SHEA HOMES
603 South Valencia Avenue
Brea, California 92823

May 18, 2005
Work Order 500653

Subject: **GEOTECHNICAL REVIEW OF
40-SCALE ROUGH GRADING PLAN**
Tentative Tract 16187
2800 North Farmers Drive
City of Santa Ana, California

PROJECT ADDRESS:
 2800 N. FARMERS DRIVE
 SANTA ANA, CA.
ROUGH GRADING PLAN
TENTATIVE TRACT 16187
 PUBLIC WORKS AGENCY
 CITY OF SANTA ANA
 SHEET 2 OF

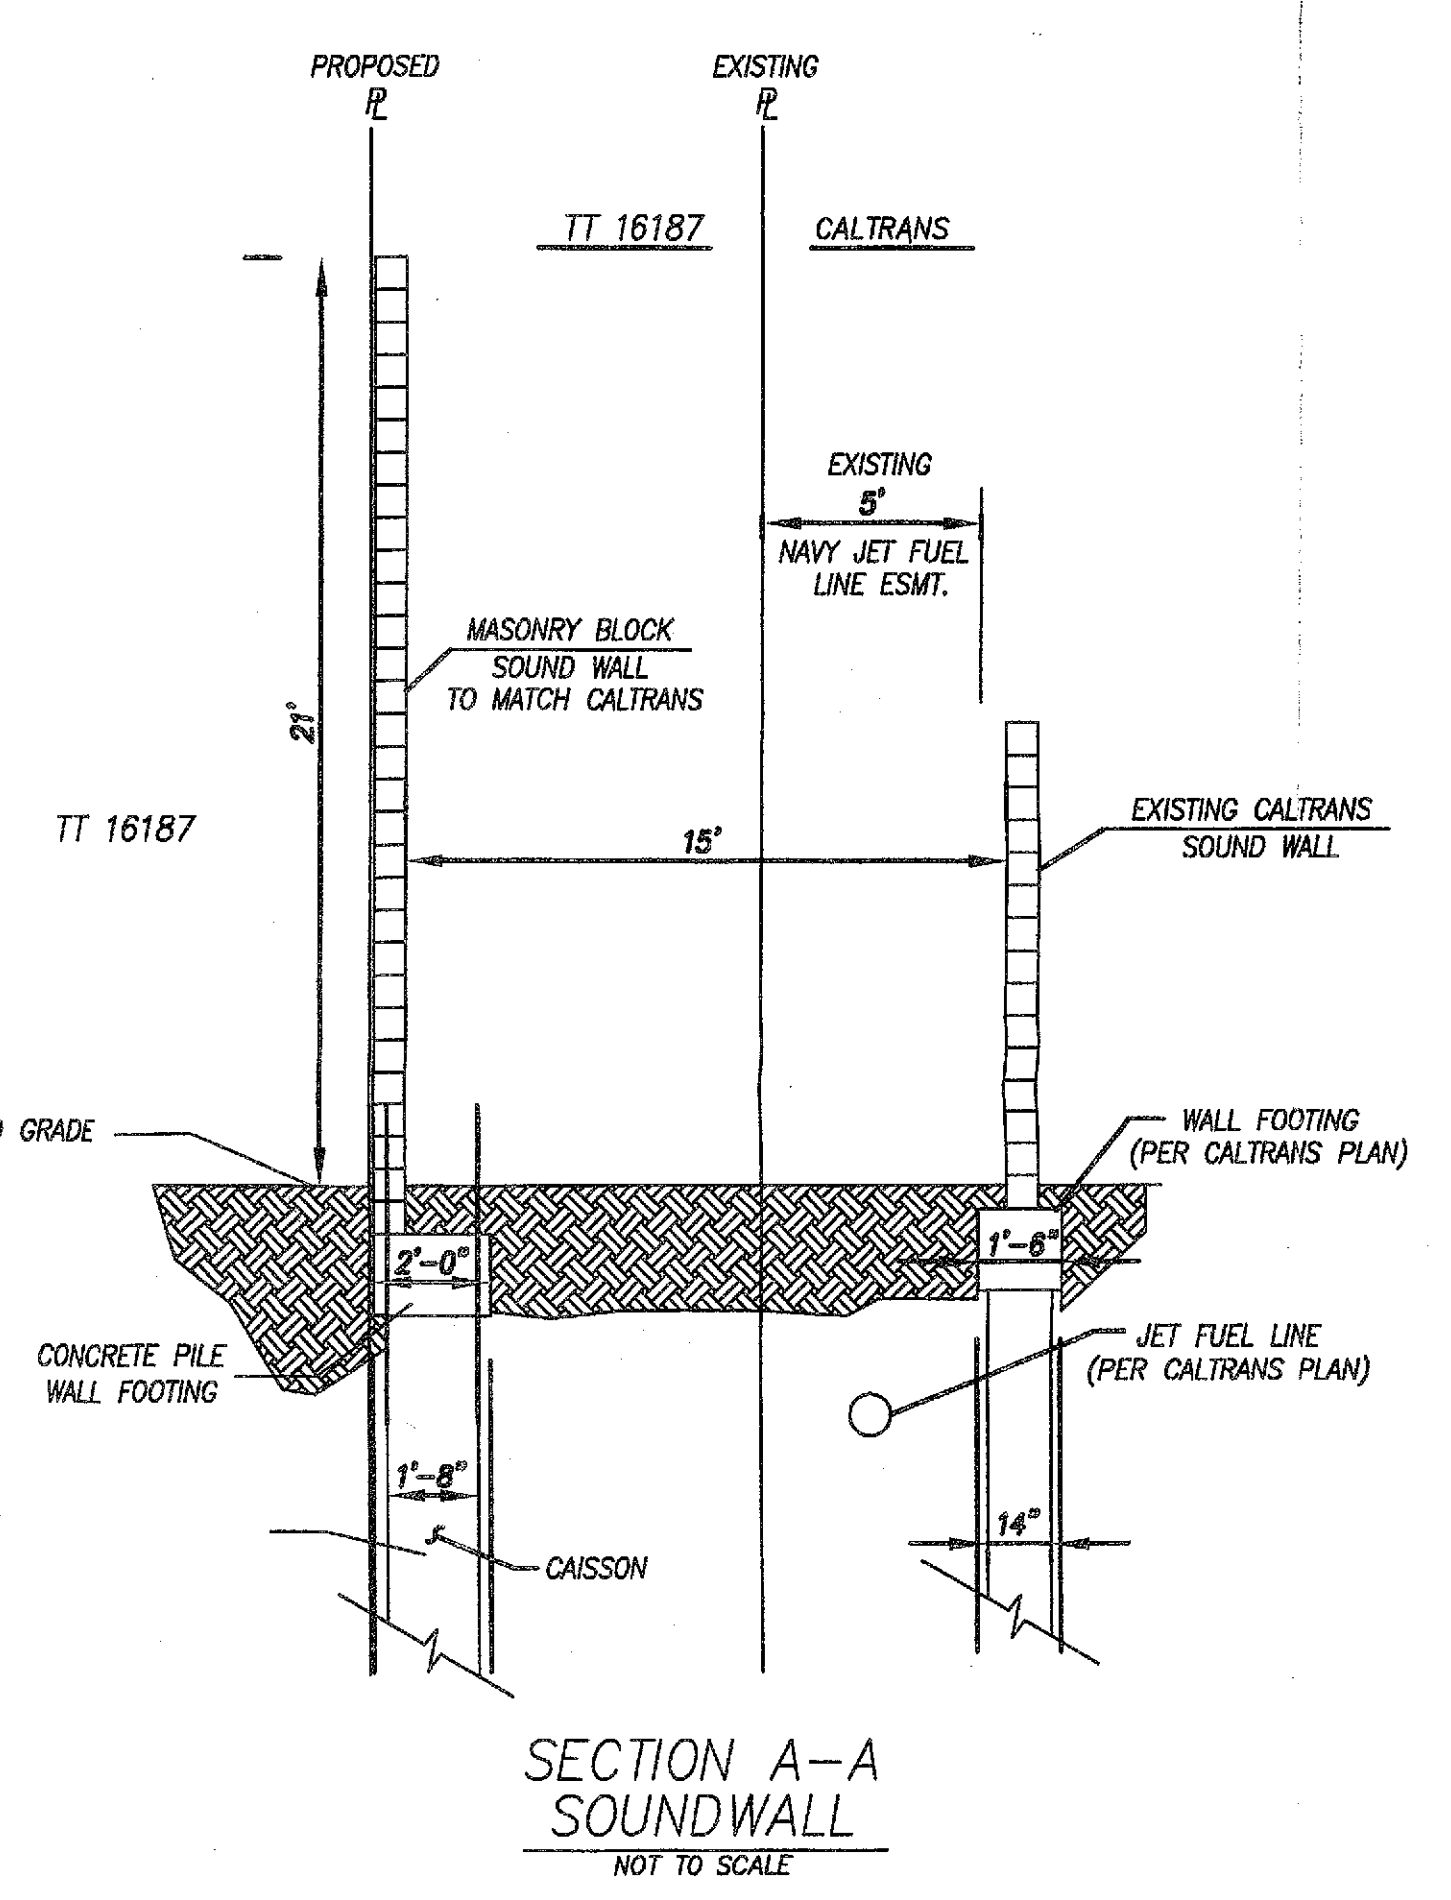
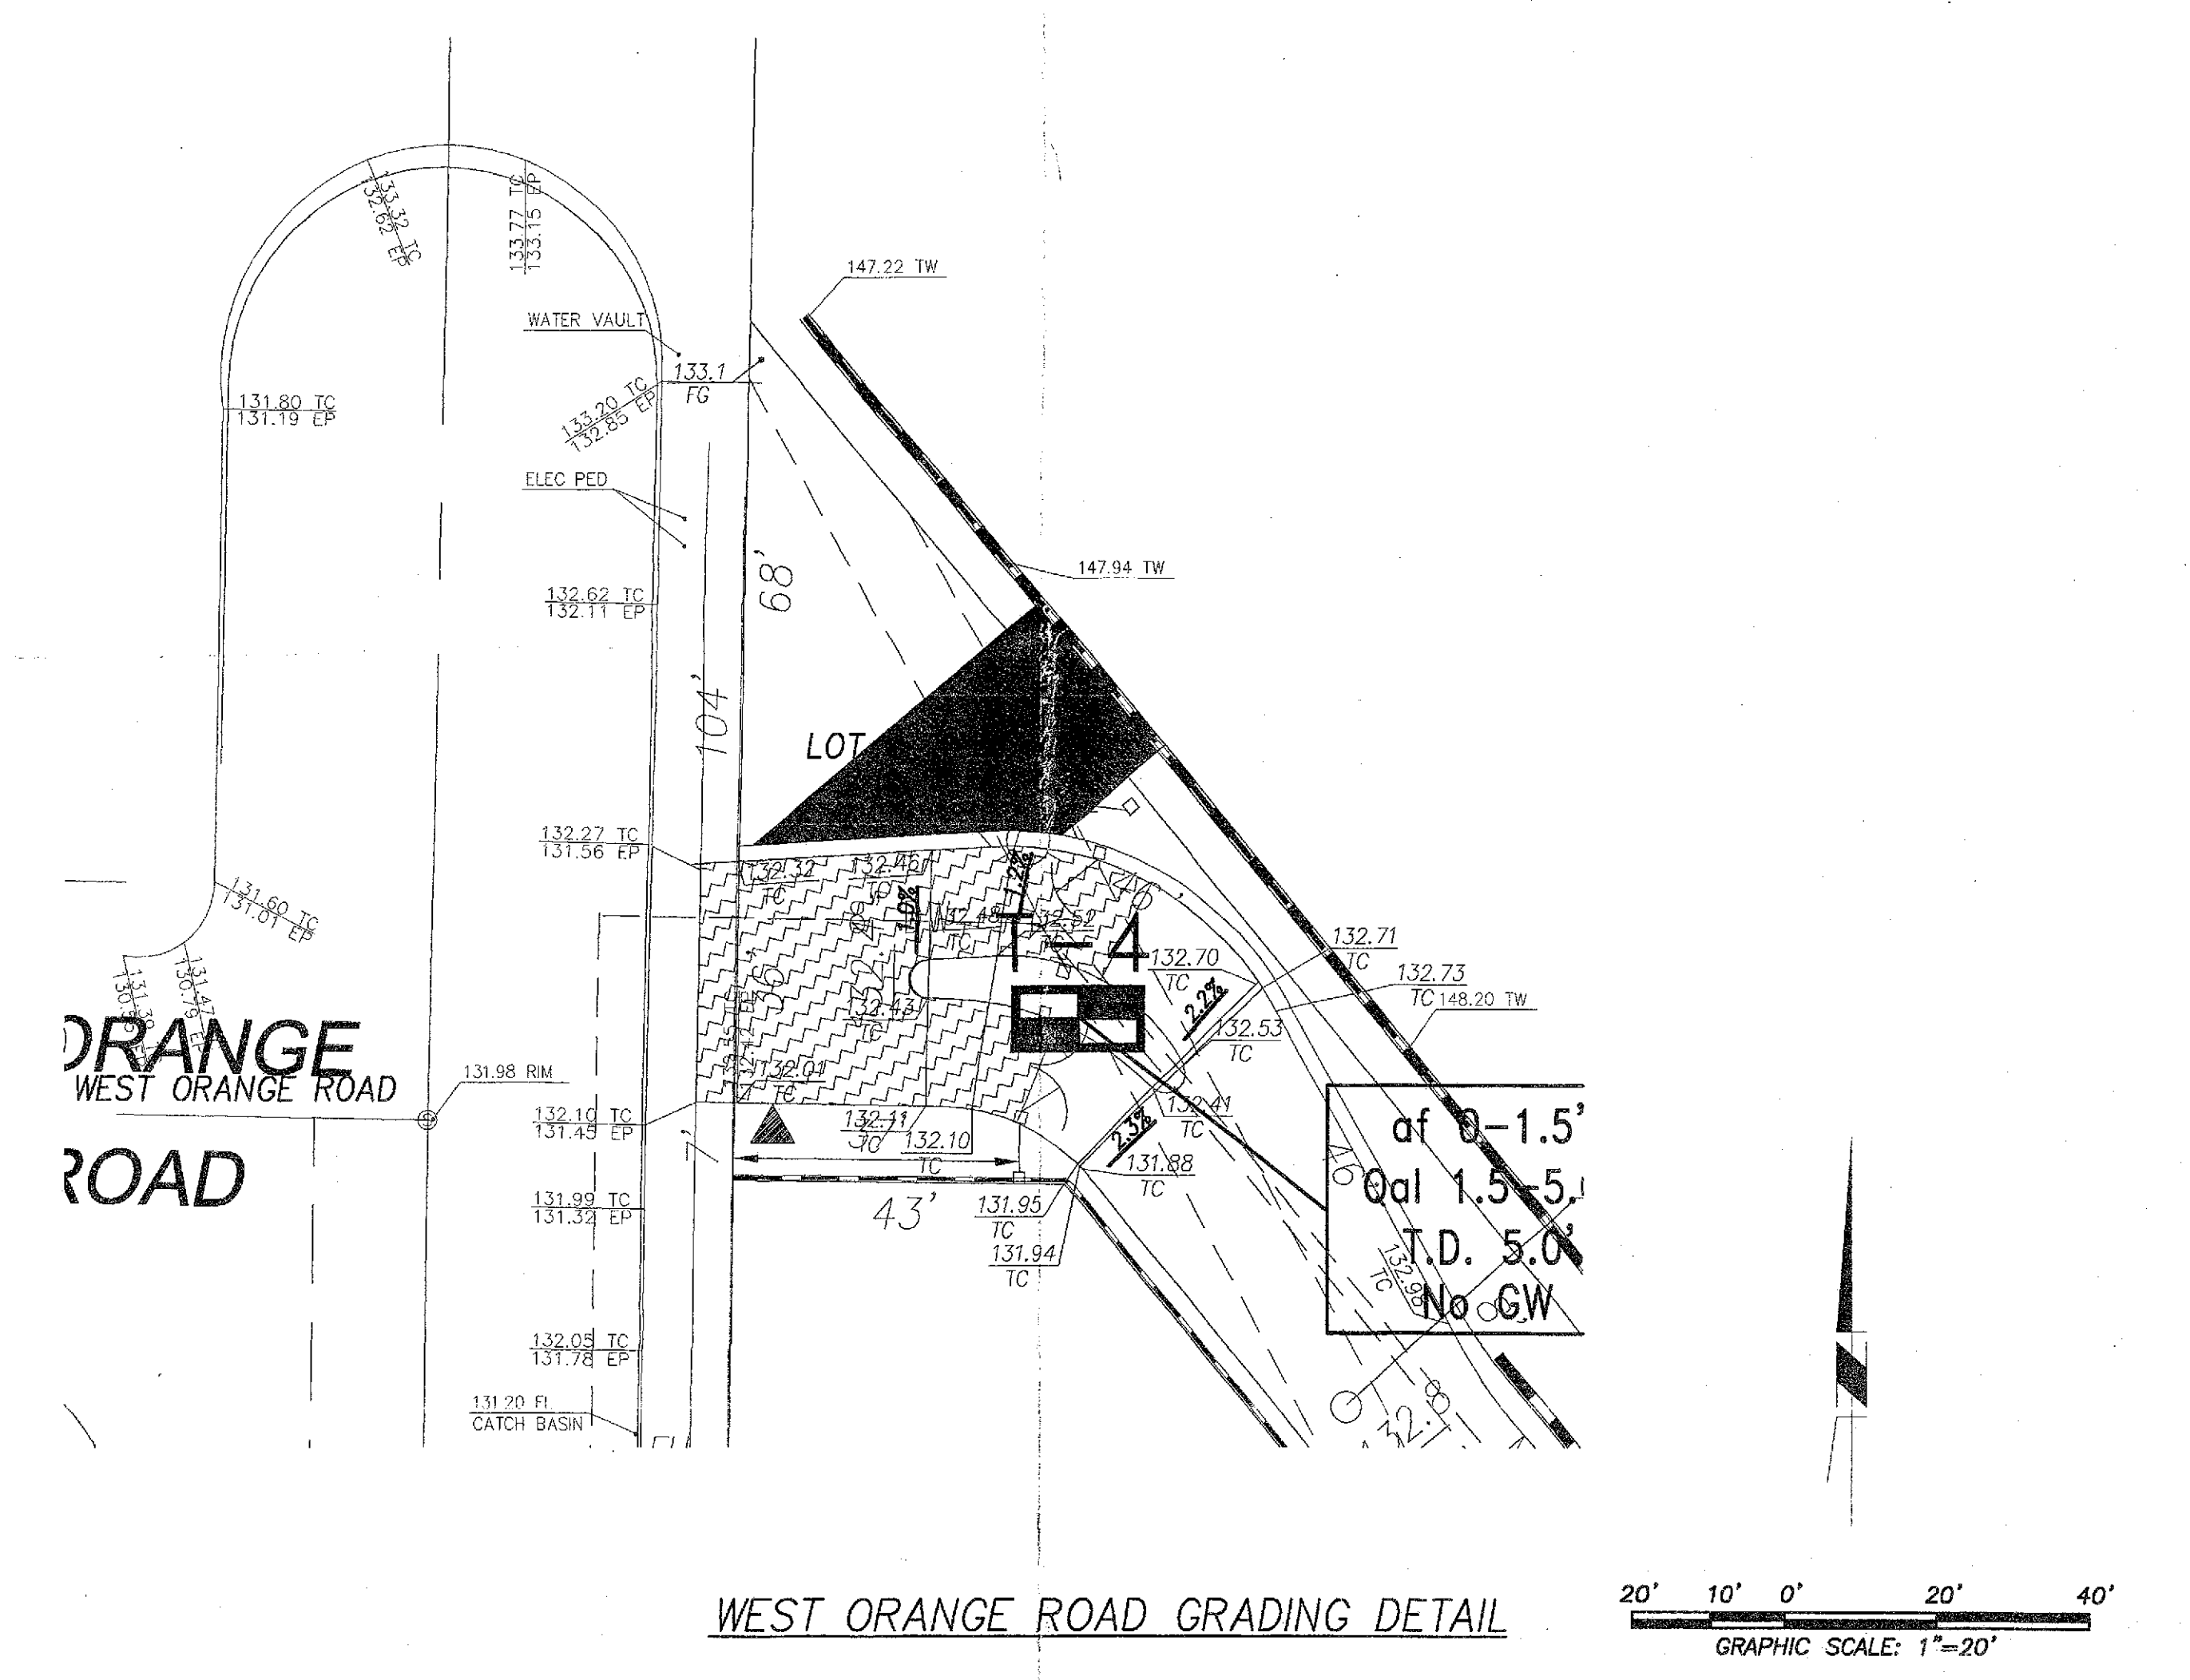
- Existing fill and underlying topsoil or unsuitable alluvial deposits should be removed. Generally, removal depths are anticipated to extend one (1) to five (5) feet below the current grade.

- Building areas should be overexcavated a minimum of five (5) feet below pad grade and street and parking areas two (2) feet below the subgrade.
- Numerous pieces of geotechnical fabric mixed with crushed asphalt associated with demolition of the existing parking lot were encountered at the site, generally within approximately 6 inches of the surface. From a geotechnical perspective, PSE does not object to incorporating this material into fill due to the limited quantities of this material. However, from an aesthetic perspective, the presence of this material in the compacted fill may not be appealing to homeowners; therefore, PSE recommends that this material be collected and incorporated into the compacted fill placed within street areas.

- It is PSE's understanding that the pre-existing building was demolished and that concrete portions were crushed on site. Provided that the material meets the gradation and durability requirements for crushed miscellaneous base (CMB), PSE has no objection to its use. This material may also be incorporated into compacted fill; however, the placement of this mixture should be limited to within street areas or within building areas provided that it is greater than three feet below the finished grade in building areas.

According to the Rough Grading Plan, it is proposed to found the sound wall on 18-inch diameter caissons. The passive resistance to be used in the design should be 350 psf/foot to a maximum of 4,000 psf. Lateral bearing of the upper two feet
